ADDENDUM #5

RFP Number: 23-016-3340	Title: Antioch Water Treatment Plant Phase 3A Expansion
	Date: June 8, 2023
Issuing Officer: Greg Bridges	Bid Initially Solicited: April 27, 2023
Email Address: gebridges@forsythco.com	Telephone: 770-888-8872

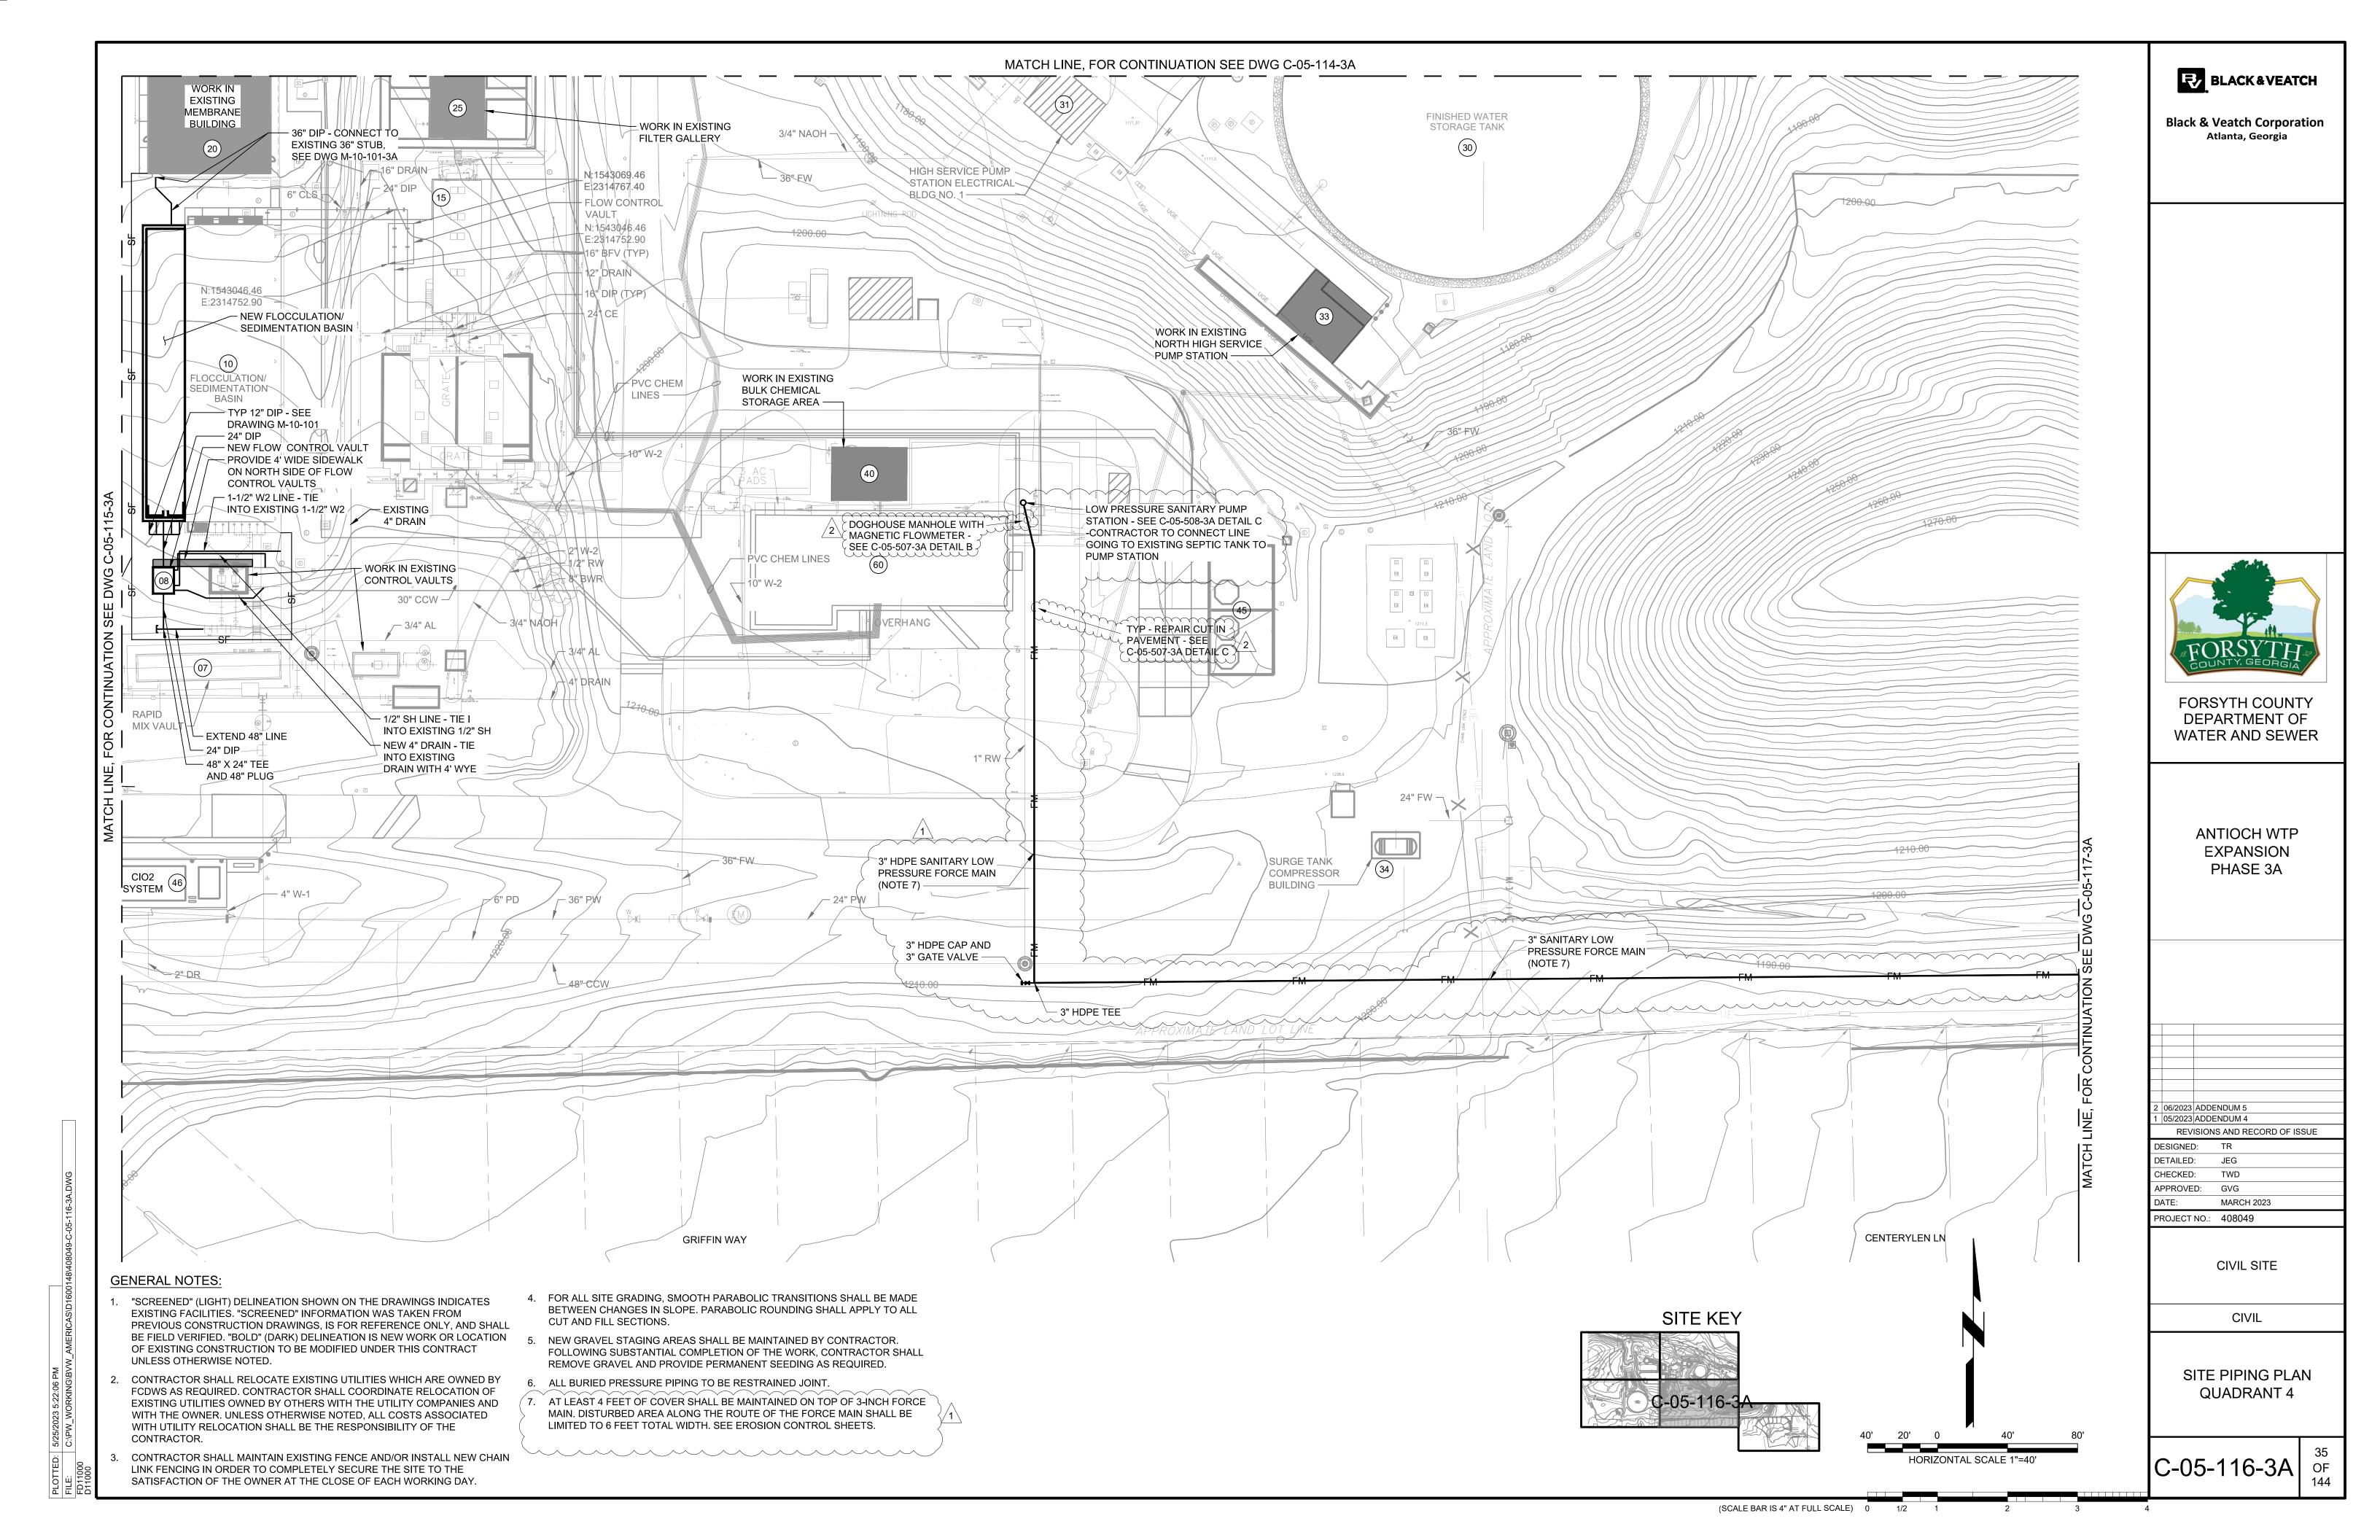
52.	Drawing C-05-117-3A shows a jack and bore creek crossing. In lieu of jack and bore, does the contractor have the option to install the steel encasement pipe utilizing trenching and pump around method?	C-05-117-3A	The requirement is for pipe encasement under the creek, which can be installed by jack and bore or by trenching.

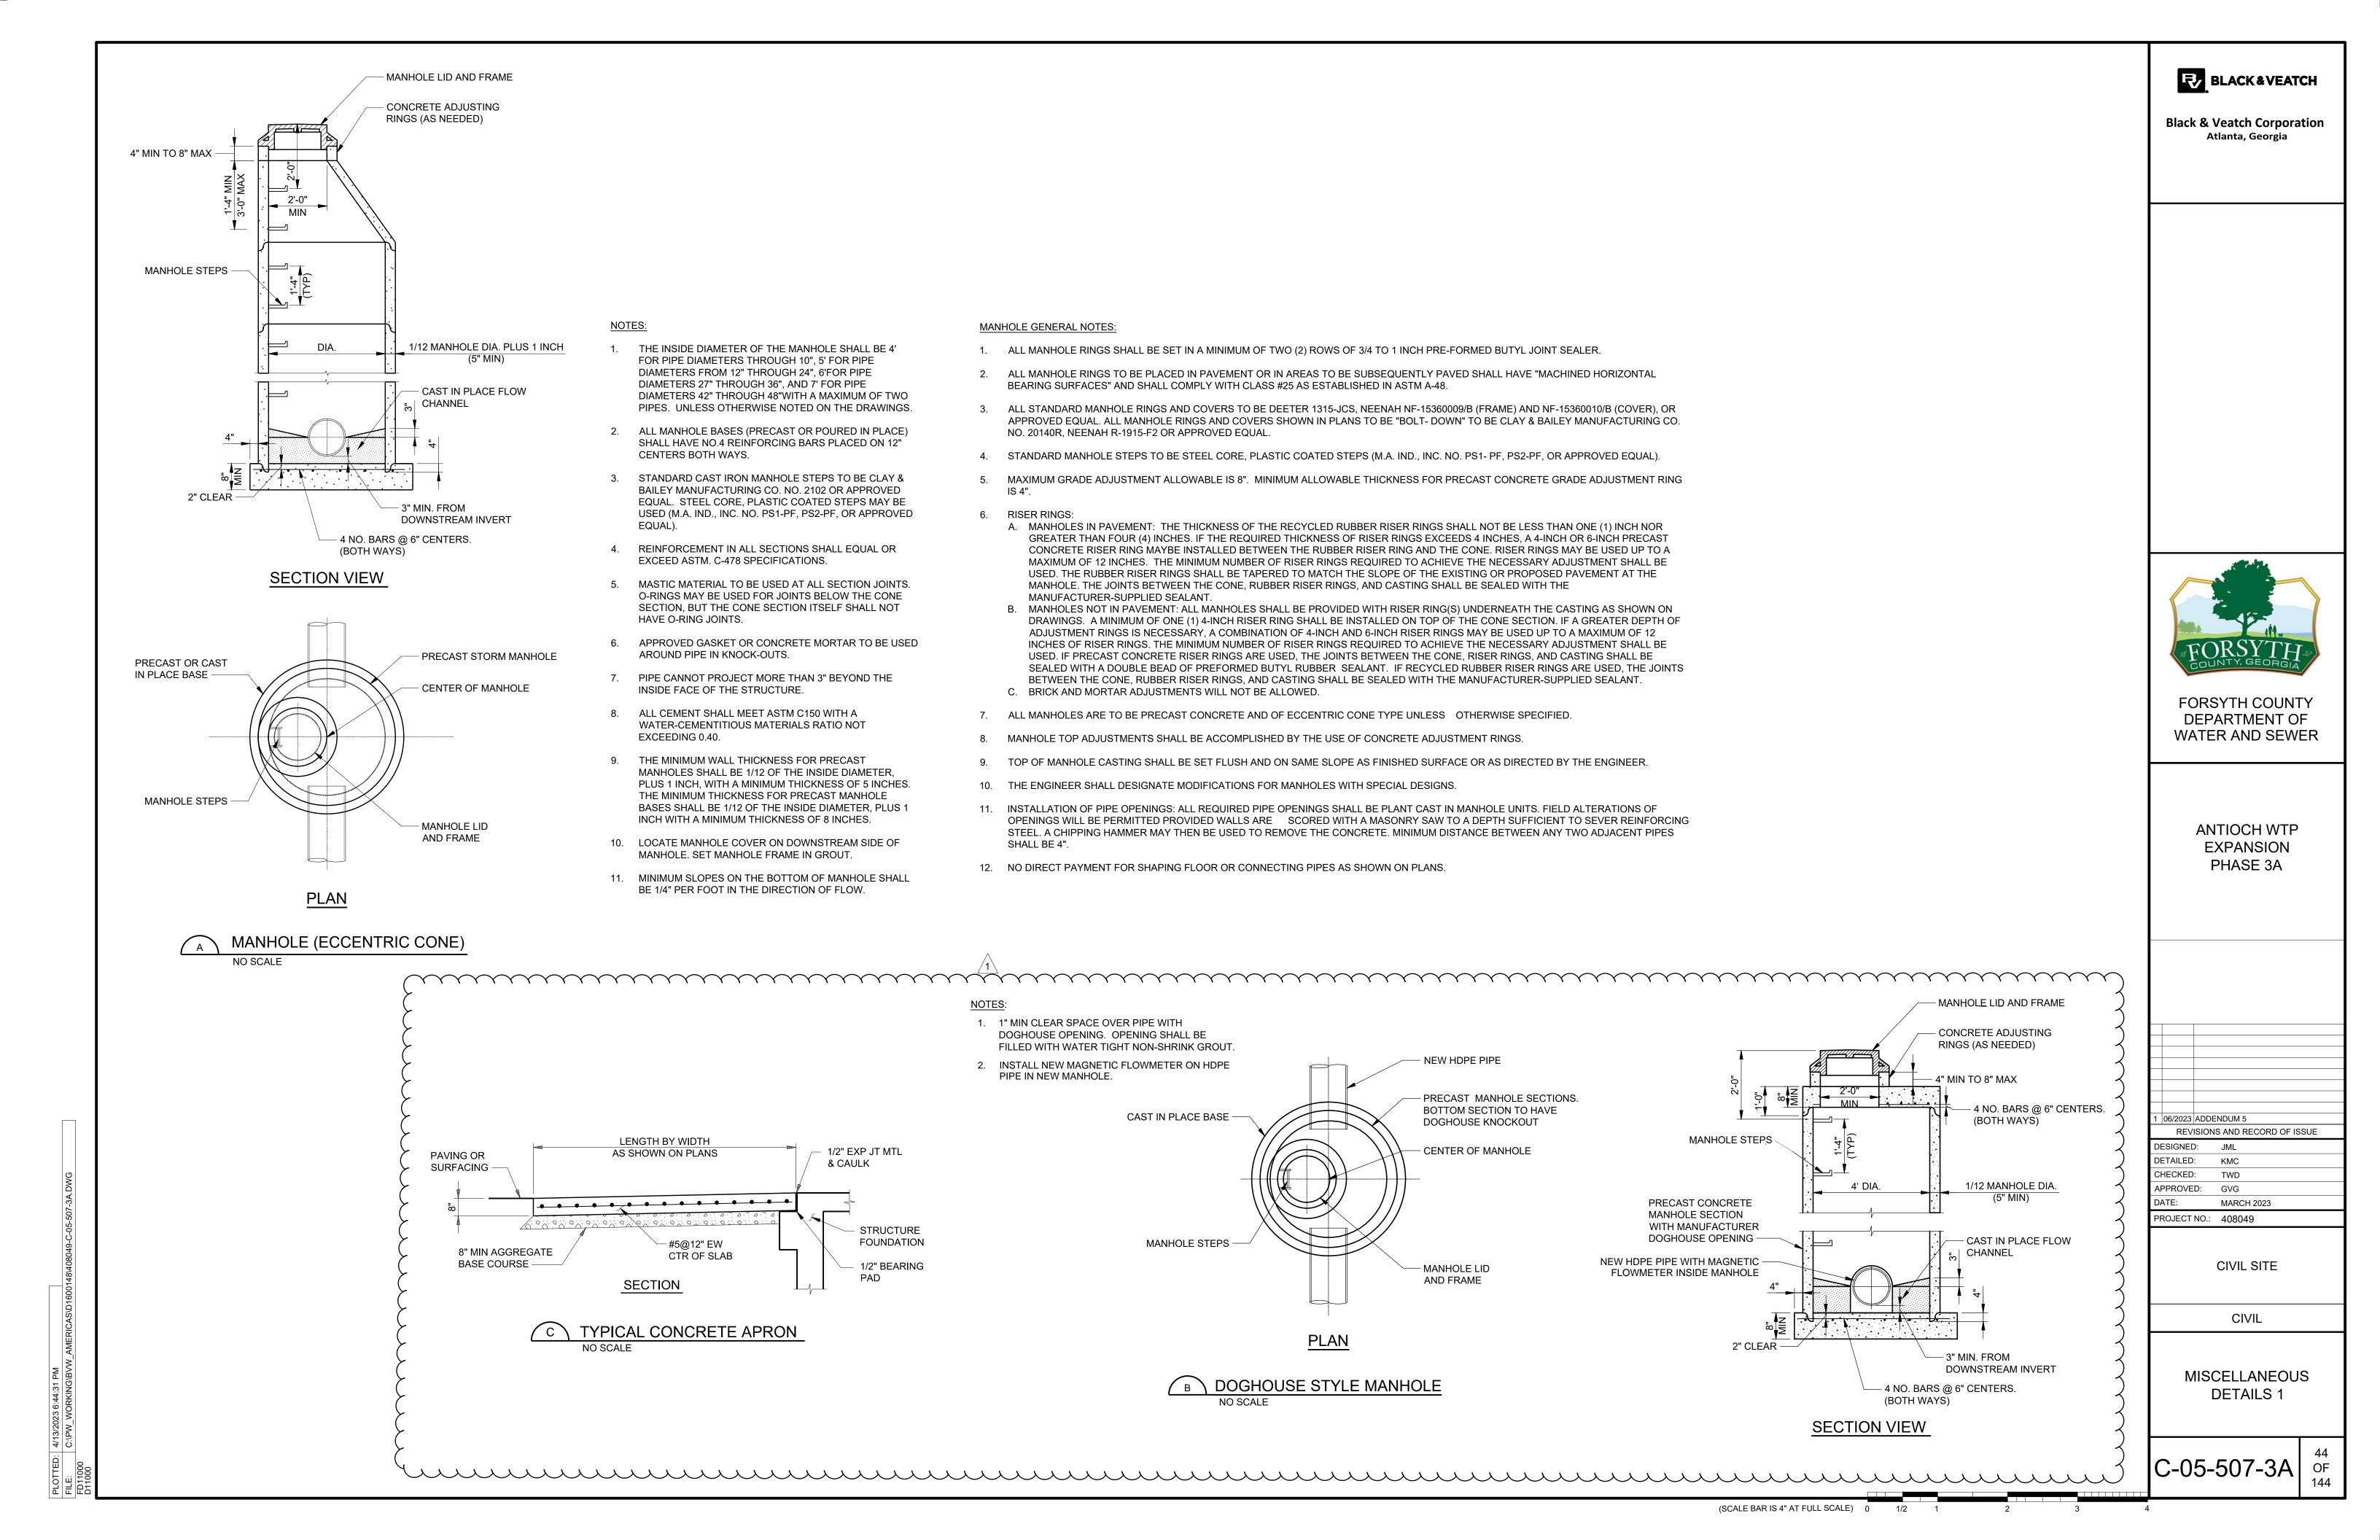
54.	Drawing M-20-101-3A, General Note #1, states that "only larger items to be constructed "by others" are indicated on these plans for reference". Is the contractor to assume that the new membrane cassettes, new process pumps, and new blower assembly will be installed by others? Similarly, should the contractor assume that the new turbidimeter assembly shown on Drawing M-20-301-3A, and the new ejectors assembly shown on Drawing M-20-302-3A will be installed "by others"?	Drawing M-20- 101-3A	No – all of these items are to be installed by the Contractor.

55.	The scope of work shown at the North High Service Pump Station requires the contractor to install new 30" BFV and a restrained DMJ of the same diameter. Should the contractor assume that these new appurtenances will fit through the hatch installed at the top-slab, or that the scale of the hatches shown on Drawing M-33-101-3A are accurate, or will the Engineer provide as-built dimensions of these openings? Note that the covers are fixed in-place, which doesn't allow Contractors to verify at the site.	Drawing M-33- 101-3A	The Contractor will have access to the hatch above FWP No. 8 (approximate dimensions of 3'-0" by 6'-9") and the sidewalk door between FWPs No. 7 and 8 (approximate dimensions of 2'-6" by 3'-0"). Contractor to field verify dimensions.
